ADDENDUM NO. 2
February 8, 2017
CITY OF HAVELOCK
WTP BACKWASH WASTE SOLIDS HANDLING PROJECT
JOB NO. 2015020
DRAWING NO. W-3642
NCBELS LICENSE NO. F-0334
NCBOLA LICENSE NO. C312

This Addendum No. 2 consists of pages ADDENDUM 2-1 through ADDENDUM 2-94.

BIDDERS are hereby notified of the following changes in the specifications and drawings.

WASTEWATER SETTLING BASIN PLAN

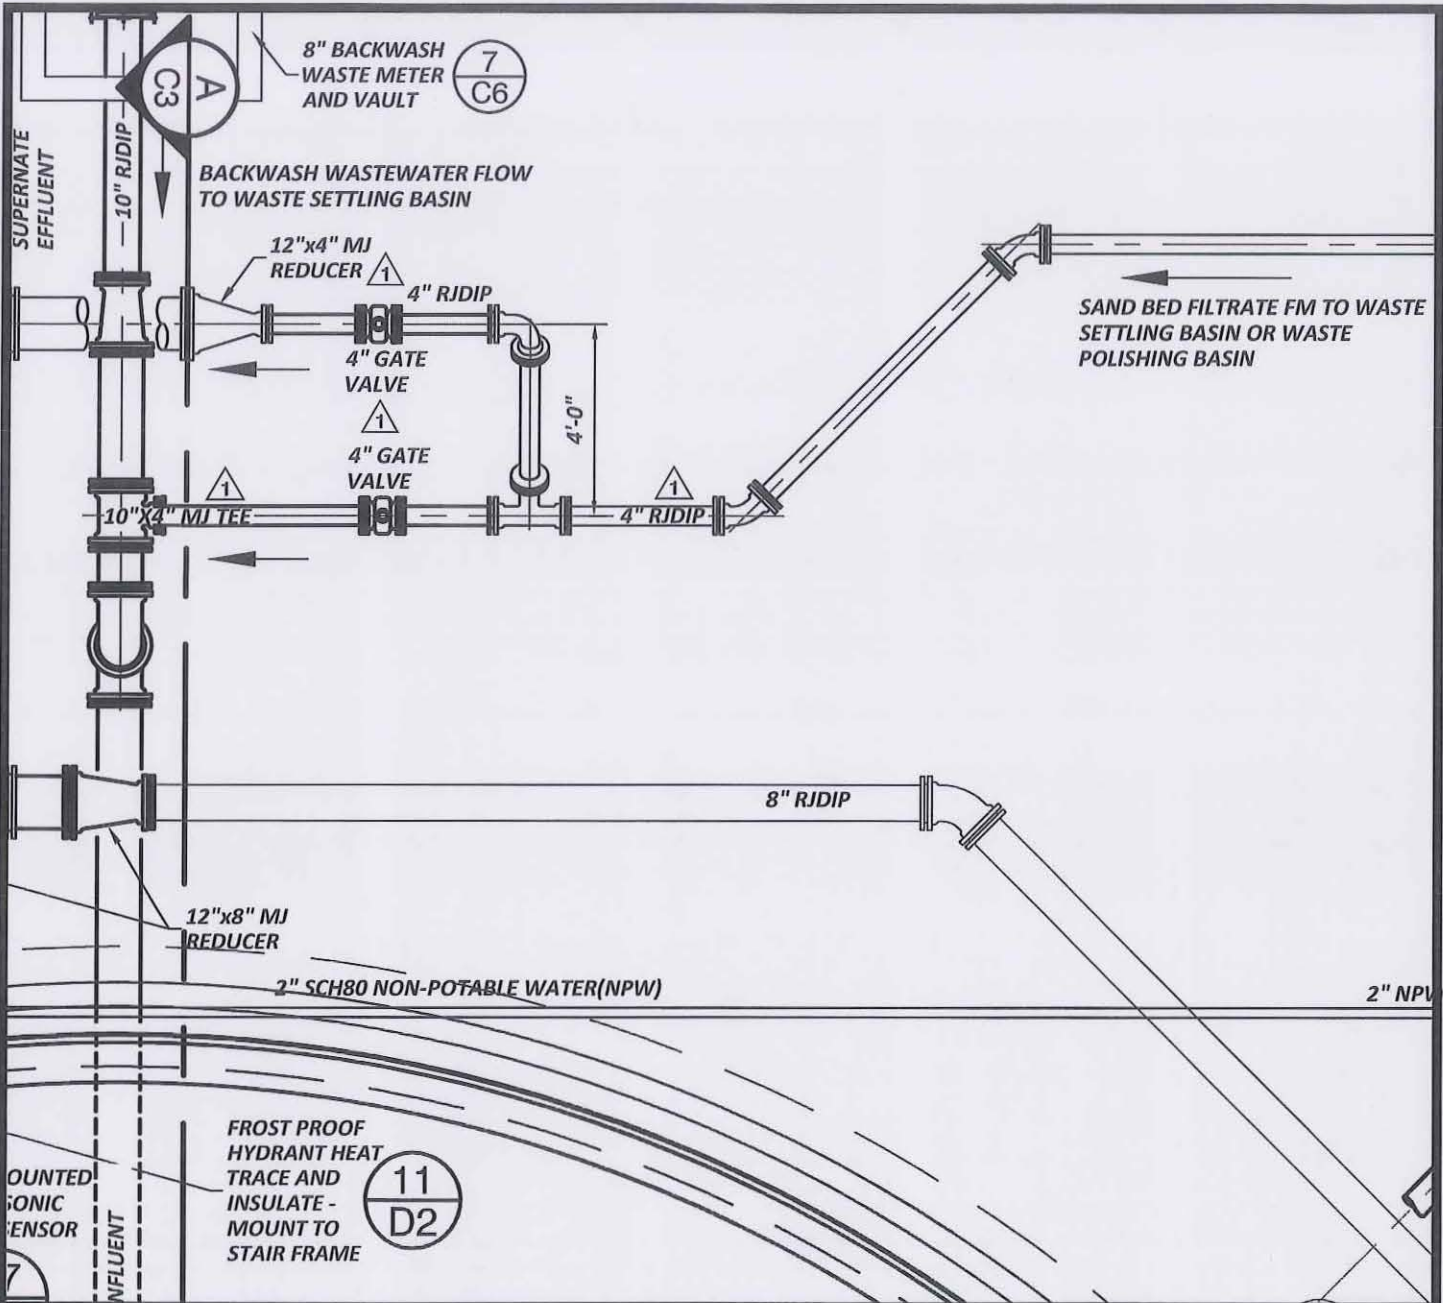
SHEET C2 – DELETE “GEOTEXTILE” and arrow pointing to interface between stone and concrete. ADD “GEOTEXTILE – 8 oz non-woven” with arrow pointing to interface between the soil and the stone.

6 CLEAN-OUT (EXTERIOR)
 N.T.S.
 SS-2B

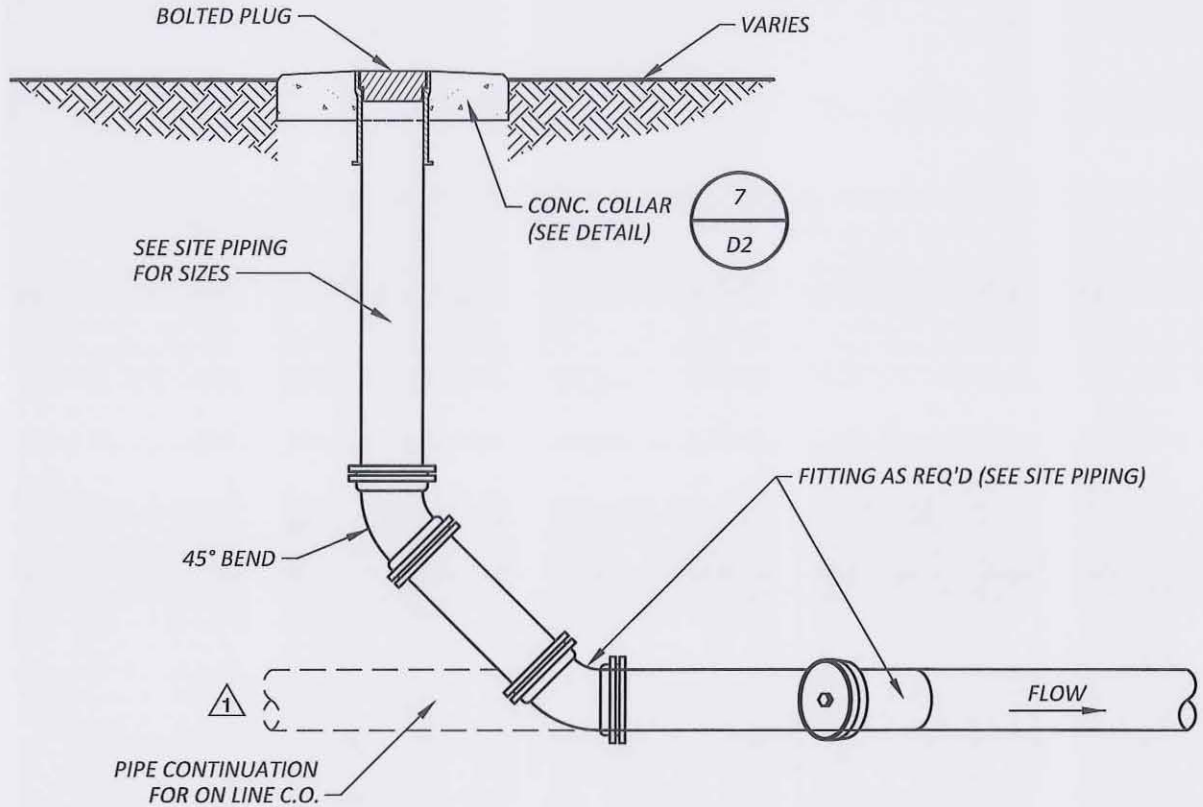
SHEET D4 – ADD Detail 6/D4, “Clean-Out (Exterior)”;

7 RPZ AND ENCLOSURE
 N.T.S. W-48A

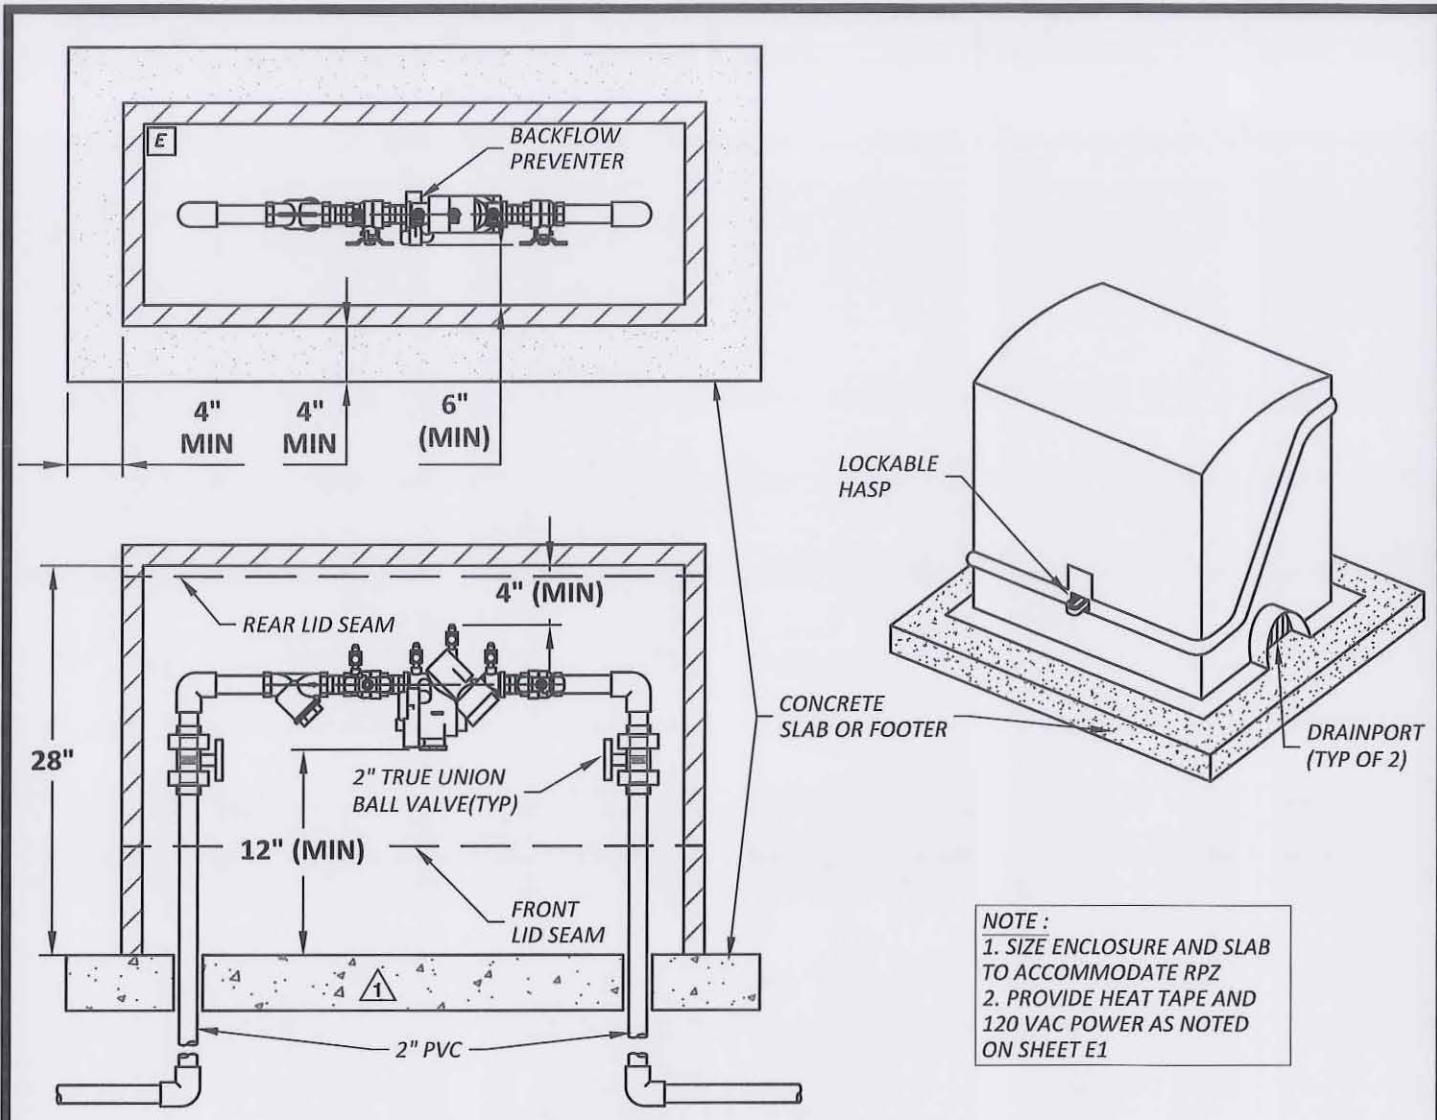
SHEET CS3 – At location near the Altitude Valve Vault and Elevated Tank, DELETE “Proposed NPW Water Meter X/Y”; ADD “Proposed Connection for NPW with RPZ 7 / D4.”

SHEET D4 – ADD Detail 7 /D4, “RPZ and Enclosure”

NOTE :
 1. SIZE ENCLOSURE AND SLAB TO ACCOMMODATE RPZ
 2. PROVIDE HEAT TAPE AND 120 VAC POWER AS NOTED ON SHEET E1
